DUKE POWER COMPANY

Re: Catawba Nuclear Station, Units 1 and 2  
Docket Nos. 50-413 and 50-414  
Proof and Review Technical Specifications

This letter supplements information regarding Figure 3.2-3, "Reactor Coolant System Total Flow Rate Versus R" presented in my November 8, 1985 letter.

FIGURE 3.2.3 RCS TOTAL FLOWRATE VERSUS R — FOUR LOOPS IN OPERATION

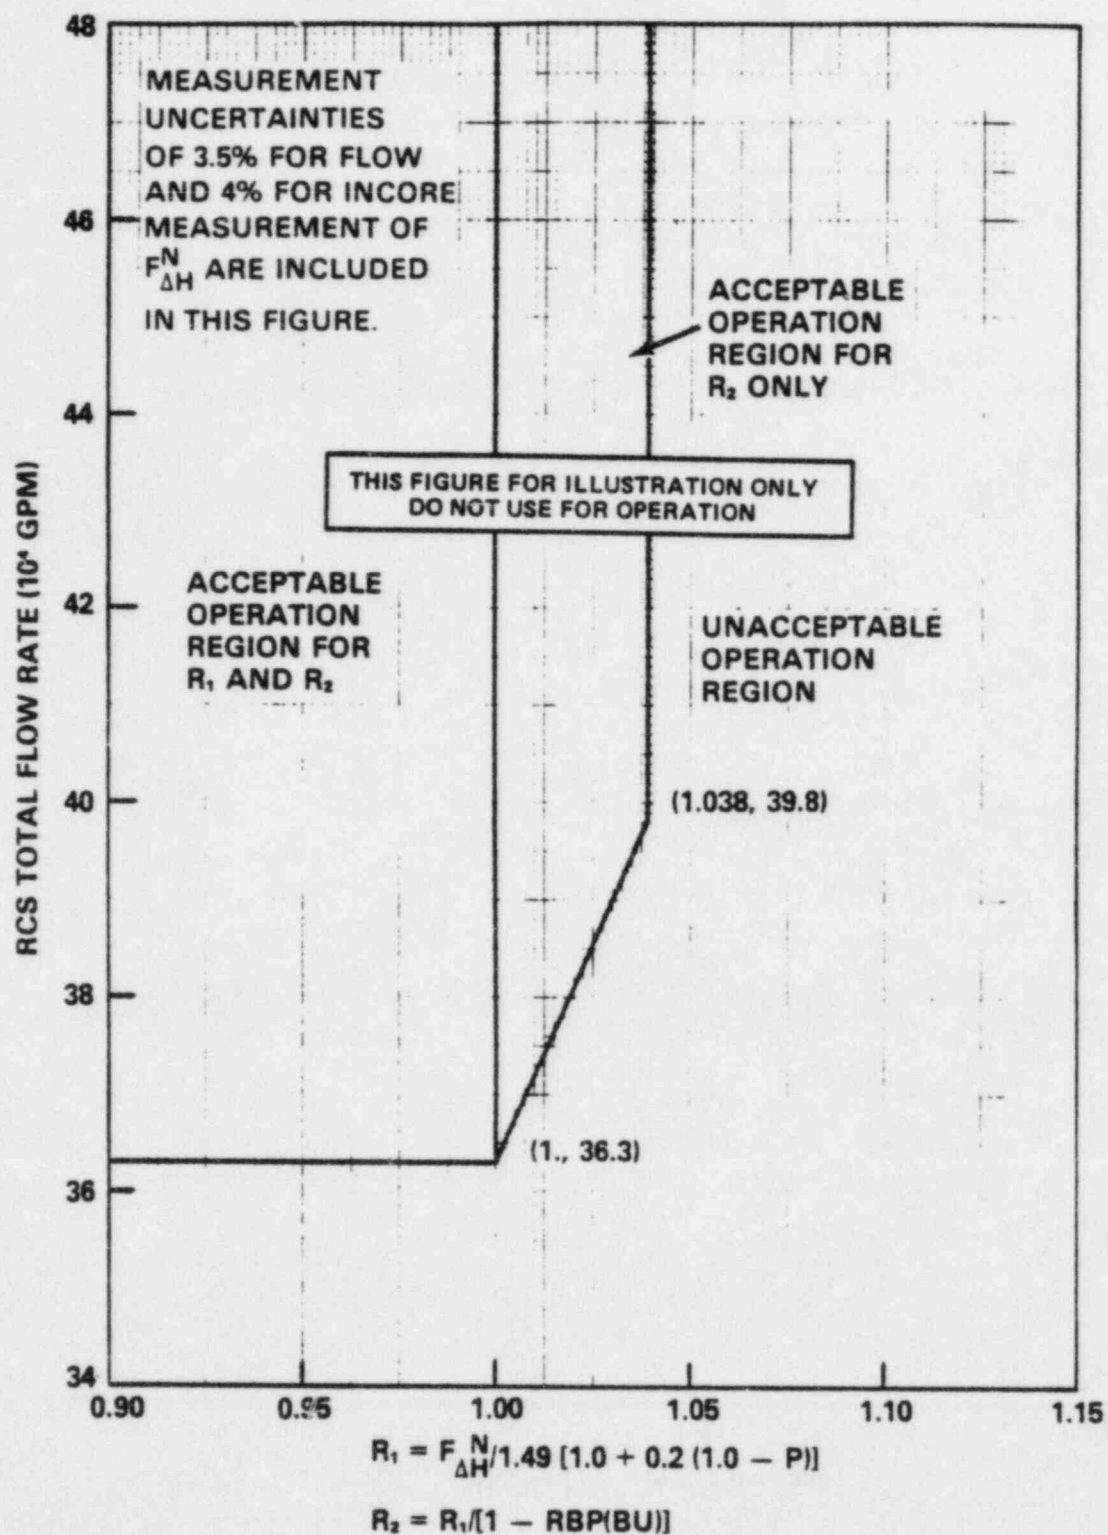
Section 3.2.3 of Revision 4 to the Standard Technical Specifications (STS) included an  $R_2$  factor.  $R_2$ , as defined in the STS, allowed for the inclusion of a penalty for rod bow on DNBR only. Thus, knowing the "as measured" values of  $F_{\Delta H}^N$  and RCS flow allowed for "tradeoffs" in excess of R equal to 1.0 for the purpose of offsetting the rod bow DNBR penalty (see attached STS Rev. 4 Figure 3.2-3 which clearly shows the operation region for  $R_2$ ).

Section 3.2.3 of Draft Revision 5 to the STS and the Catawba Technical Specifications have taken into account fuel rod bowing. Credit is provided in Figure 3.2-3 to offset the reduction in the generic margin associated with rod bow. The removal of the  $R_2$  factor has the effect of making operation outside the LOCA LIMIT line but inside the DNB LIMIT line unacceptable no matter what the actual Rod Bow Penalty is. Therefore, the DNB LIMIT line no longer serves a purpose and should be deleted from the Catawba Technical Specifications. This line should also be removed from the Draft Rev. 5 STS.
